PE2 – Development Application No. 010.2011.00000039.004 – 90 Railside Avenue Bargo – S96(2) Modification to Amend Existing Car Park Ingress/Egress and Car Parking Numbers

Development Application No: 010.2011.00000039.004
Property Details: 90 Railside Avenue, Bargo

Proposal Details: S96 (2) Modification to Amend

Report of Planning and Economy to the Ordinary Meeting of Council held on Monday 20 June 2016

- 1. Proposed modified site plan of development.
- 2. Roads and Traffic Authority comments.

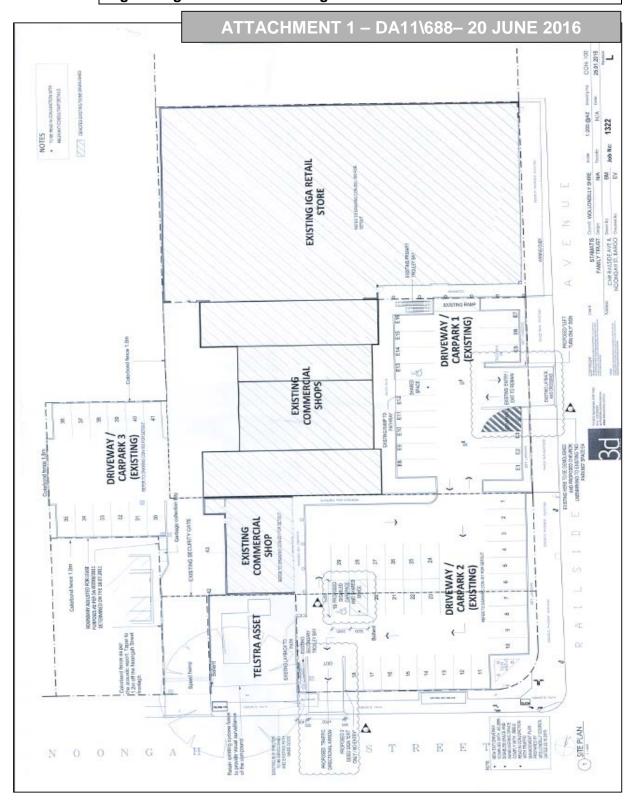
The modification impacts upon this parking area. Access would still be via a right of carriageway over Nos. 84-86 Railside Avenue. Circulation within the parking area would then become one-way and a new exit point would be constructed onto Noongah Street. As a result, the car park spaces will be reduced from 45 to 43.

In the latest amendment to the proposal, the applicant is seeking to retain the existing access/egress from Railside Ave while adding another egress only point on the Western side of the existing Noongah Street car park. As part of the proposal, the applicant is also suggesting to remove an existing kerb to the existing "E4" car space in order to create a wider swept turning path for vehicles entering the site. It is important to note that space E4 was already a "no parking" space and so is not expected to have any negative impacts.

As a result of these changed traffic conditions, 2 of the existing 45 car spaces have been removed in order to achieve better outcome in regards to traffic flow within the site. The existing disabled car space was also re-positioned to a location which is better suited to the proposed altered traffic conditions.

- 4. The following conditions are added to 11. Engineering & Construction Specifications:
  - (7) The applicant shall construct a new heavy duty concrete access (exit only) in Noongah St and alter the parking to relocate the Disabled Parking space as generally shown on the concept plan by Building Designers Australia (3d evolution) dated 25 January 2016. This exit shall include the installation of kerbs each side to delineate the access & provide separation to the parking & trolley bay. Details of this must be provided on engineering plans and approved by Council's Infrastructure Planning Section, under Section 138 of the Roads Act 1993. Engineering plan checking and inspection fees will be advised for payment prior to the issue of the approved plans and 138 Consent Certificate.

- (8) The applicant shall carry out alternation works in Railside Ave. entry/exit generally as shown on the concept plan by Building Designers Australia (3d evolution) dated 25 January 2016. Details of this shall be included on the engineering plans for approval by Council's Infrastructure Planning Section.

- (9) The applicant shall install signage, including Exit only and No Entry for the Noongah Street access, and provide line marking for the proposed alternation works generally as shown on the concept plan by Building Designers Australia (3d evolution) dated 25 January 2016. Details for this shall be included on the engineering plans.
